East Anglia ONE North and East Anglia TWO Offshore Windfarms

Applicants' Responses to Examining Authority's Written Questions 2

Volume 6 – 2.10 Landscape and Visual Impact

Figure 1 Average Rainfall Amount 2009-2020

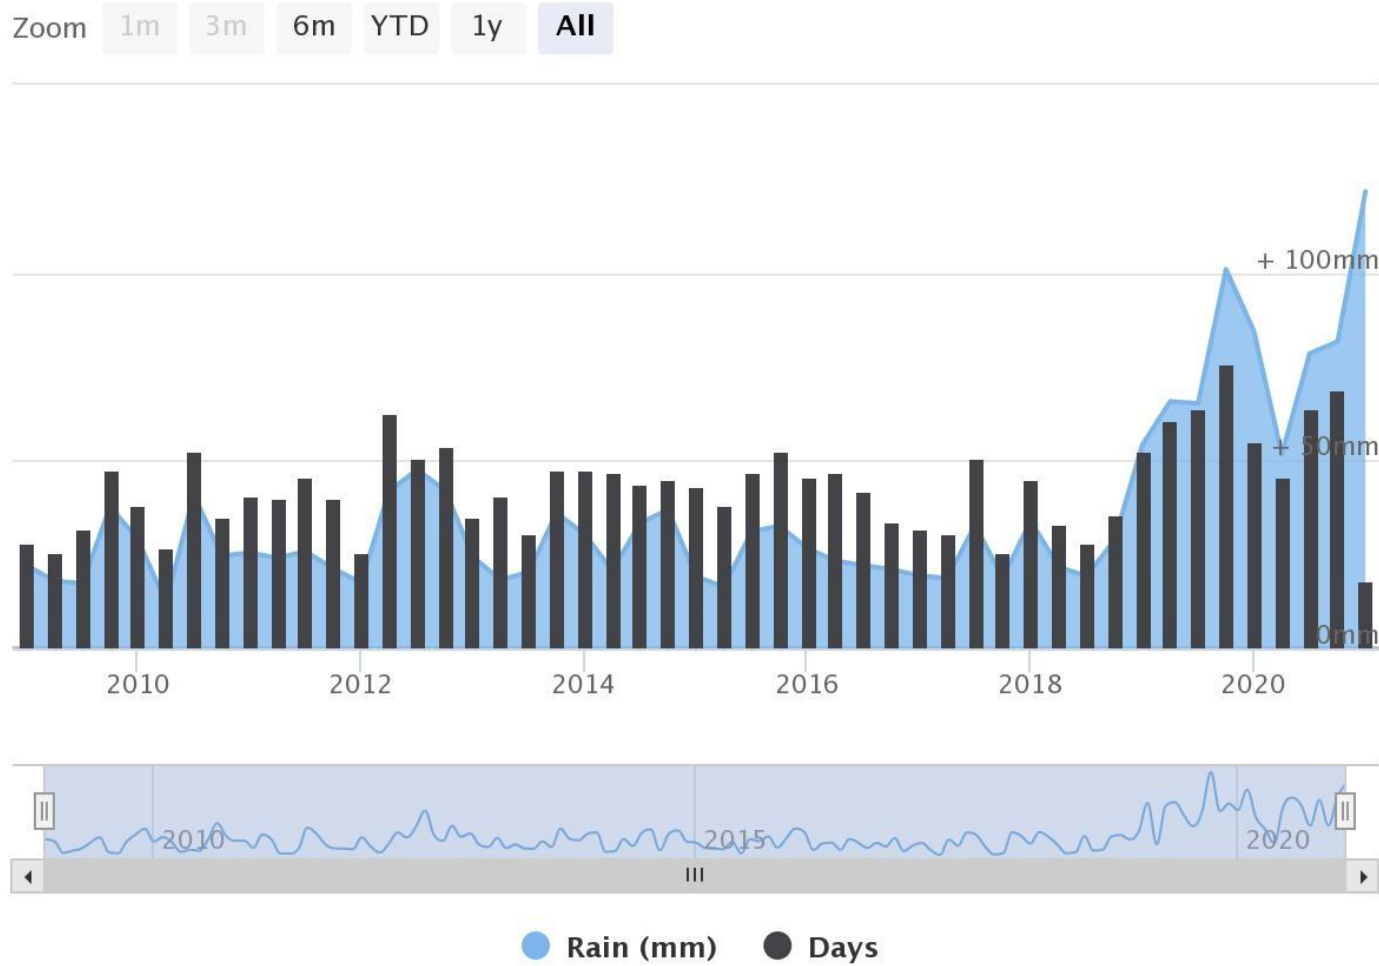
| ExA. Question Ref. | Question addressed to | ExA. Question | Applicants' Response |
|--------------------|-----------------------|--|--|
| | | <p><i>levels of plan growth and provide greater confidence that effective screening from the tree planting areas will be achieved before the end of the adaptive management period” [REP5-010]</i></p> <p>a) Respond to the view of SPS that growth rates do not typically exceed 300mm a year and that the visualisations suggest a height of 8-9m.</p> <p>b) How likely are 15 consistently favourable consecutive growing years, with reference to recent experiences in East Suffolk and climatic conditions?</p> <p>c) If 15 consistently favourable consecutive growing years are not likely to be achieved, will the adaptive management scheme allow, for instance, for the removal of underperforming stock and replacement with more mature samples?</p> <p>d) Given your answers to a), b) and c), how realistic do you consider the revised photomontages submitted to be?</p> <p>e) Will further information on the adaptive management scheme be provided in a future OLEMS, and if so, when will this be provided to the Examinations?</p> <p>f) Respond to the views of SPS that artificial irrigation is not guaranteed to support robust growth in the long term and that such methods are an unsustainable approach to horticulture, particularly considering climate change.</p> | <p>b) The Applicants note concerns regarding the potential for dry spring/summer conditions in Suffolk to hamper plant establishment and will ensure that the LMP includes provision for the implementation of adequate watering of newly planted and established trees during the aftercare period. The Applicant has reviewed monthly precipitation data for the last 20 years (see Figures 1 and 2 at the end of this document) from East Suffolk (Ipswich). Average rainfall amounts have been greatest over recent years during 2019-2020, compared to the period 2009-2018. Longer term data over the 10-year period 2009-2020 shows that monthly rainfall days/amounts are broadly consistent over the long-term, albeit with monthly variability, and that the rainfall amounts are likely to provide favourable consecutive growing years provided that short periods of dry weather/lower rainfall are monitored and mitigated by watering provision through the aftercare period. Taking 2020 as an example, monthly average rainfall days ranged from a lowest of 13 days in May to a highest of 29 days in October, with no months recording any lower than 13 rainfall days and there was an average of 19.5 days monthly rainfall across the year. The average rainfall amount (mm) over the year ranged from a lowest of 24.9mm in May to a highest of 110.1mm in February. Although the rainfall data for 2020 points to a slightly lower number of rainfall days and rainfall amount in spring in April/May, both months had 13 rainfall days and between 24.9mm – 47.1mm of rain in 2020. The adaptive maintenance aftercare provision will include adequate watering of new planting stock during this important plant establishment period during Spring and as required throughout the year. The 2020 data shows that during the summer months of June to August there were between 20-25 rainfall days and between 83.1mm (June) to 97.4mm (August) rainfall amount – where warm and wet conditions are very likely to be conducive to good plant growth.) The Applicant proposes to prepare</p> |

| ExA. Question Ref. | Question addressed to | ExA. Question | Applicants' Response |
|--------------------|-----------------------|---------------|--|
| | | | <p>a LMP based upon an adaptive planting maintenance scheme (dynamic aftercare), which will allow for the focused management of underperforming stock. The aftercare supervision structure will address the annual growth of different blocks of planting, with monitoring against agreed objectives, with the option to suspend/extend the maintenance periods for discrete areas of planting and target specific measures to improve such areas, in cases where the planting does not establish satisfactorily for any reason.</p> <p>d) The Applicants recognise that there are limitations with the degree to which any visual representation can be entirely 'realistic', however the Applicants consider that within the technical limitations, the revised photomontages present accurate, objective and realistic representations of the appearance of the onshore substations and National Grid substation with the 'proposed' landscape scheme at Year 15 showing a range of tree/woodland heights which are deliverable over this period assuming appropriate preparation of soil, species, stock selection and quality of planting and aftercare.</p> <p>e) An updated OLEMS will be submitted at Deadline 6, and whilst there are refinements to the adaptive management measures proposed, no substantive additional information is proposed. The principles of the adaptive management measures set out in the OLEMS is considered appropriate for this outline document, with detail provided within the final Landscape Management Plan which requires approval from the relevant planning authority.</p> <p>f) The Applicants note the extensive use of reservoirs and irrigation systems within the East Anglia region. Given the importance of maximising the screening effect and condition of planting around the substations of such nationally significant infrastructure projects and considering the inherent ecological benefits that such landscaping will</p> |
